CORRESPONDENCE FROM SOUTH CAROLINA DEPARTMENT OF HEALTH AND  
ENVIRONMENTAL CONTROL DISCUSSING MONITORING WELL REQUEST FOR ZONE H  
CNC CHARLESTON SC  
11/3/1999  
SOUTH CAROLINA DEPARTMENT OF HEALTH AND ENVIRONMENTAL CONTROL

RE: Naval Base Charleston (CNAV)  
Charleston, South Carolina  
SC0-170-022-560

Monitoring Well Request for Zone H  
SWMU 17  
Revision 0 Dated October 22, 1999

ZONE K GRID-BASED VERTICAL PROFILE LOCATIONS

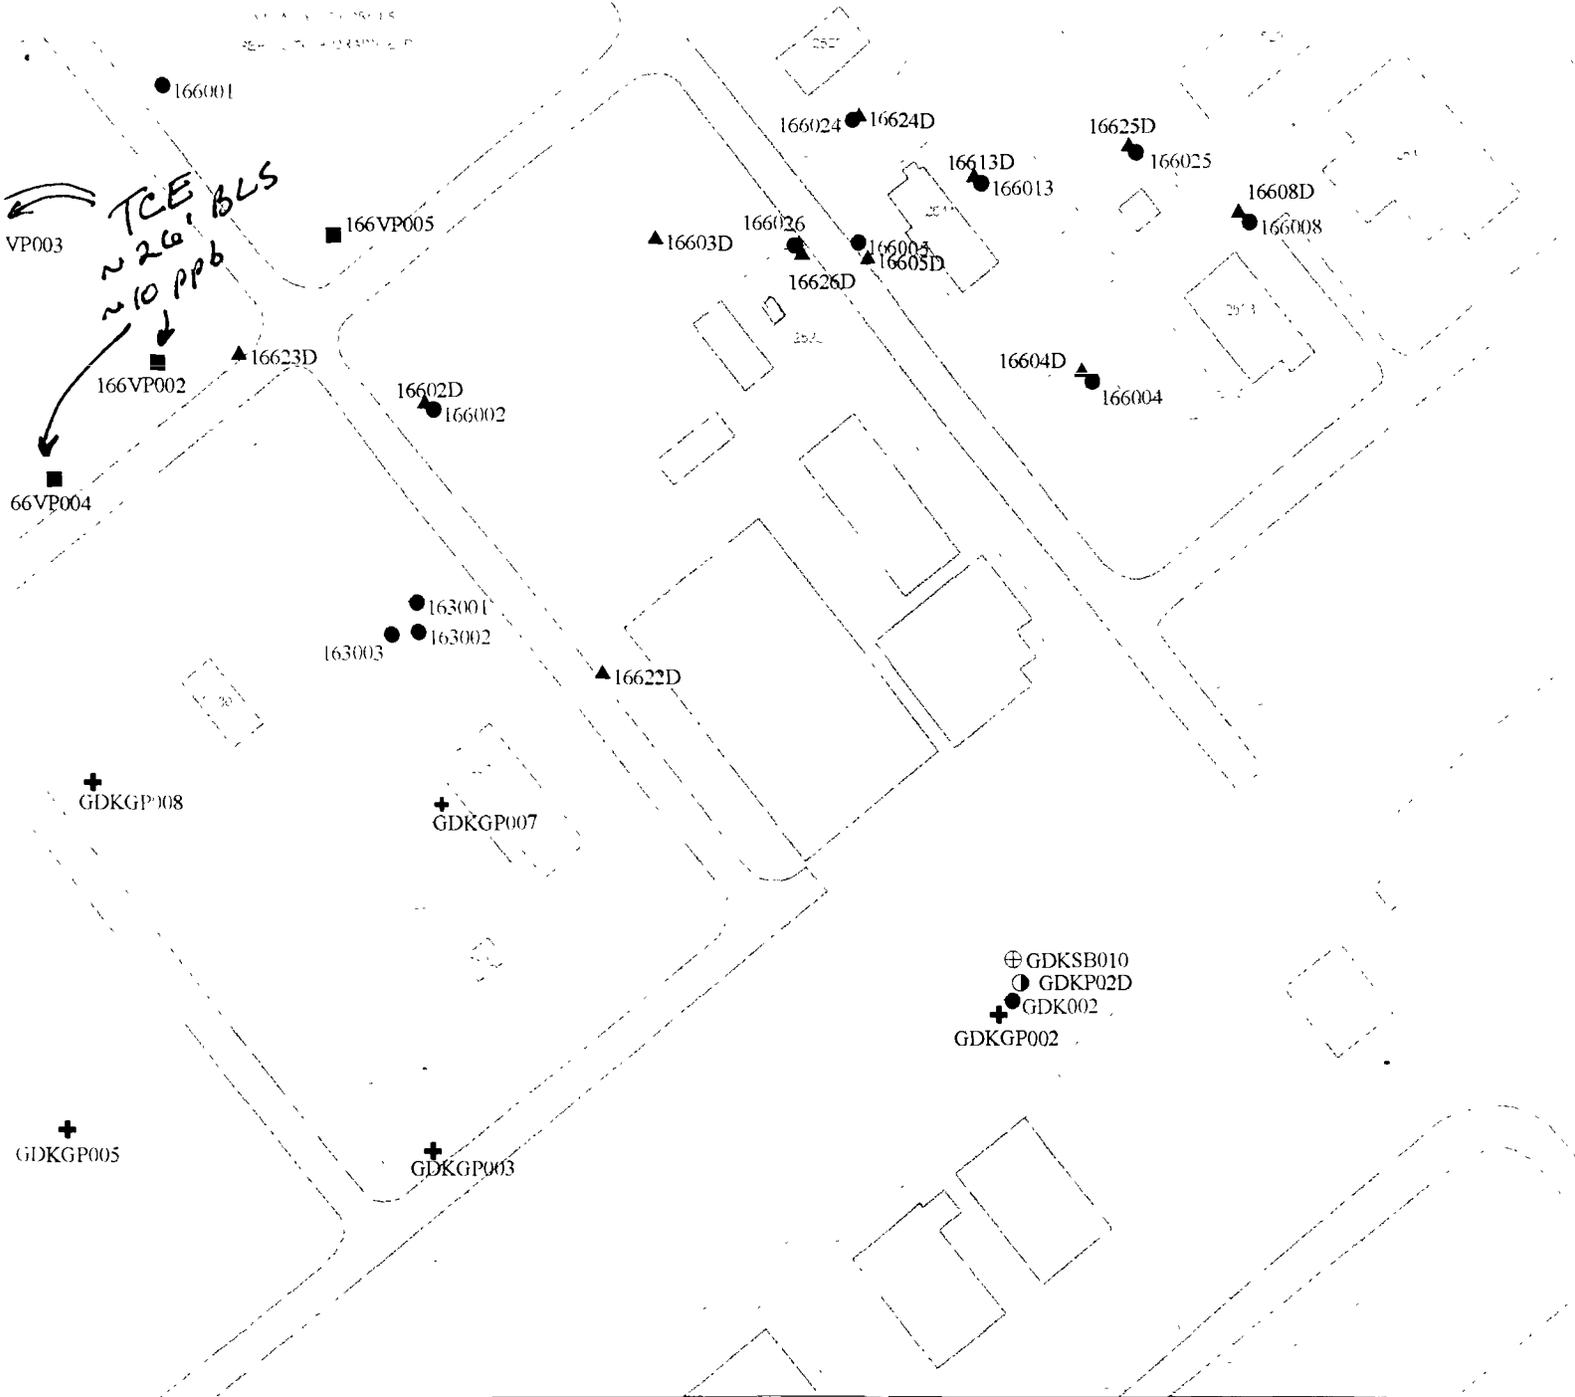
- Will Analysis include explosives?
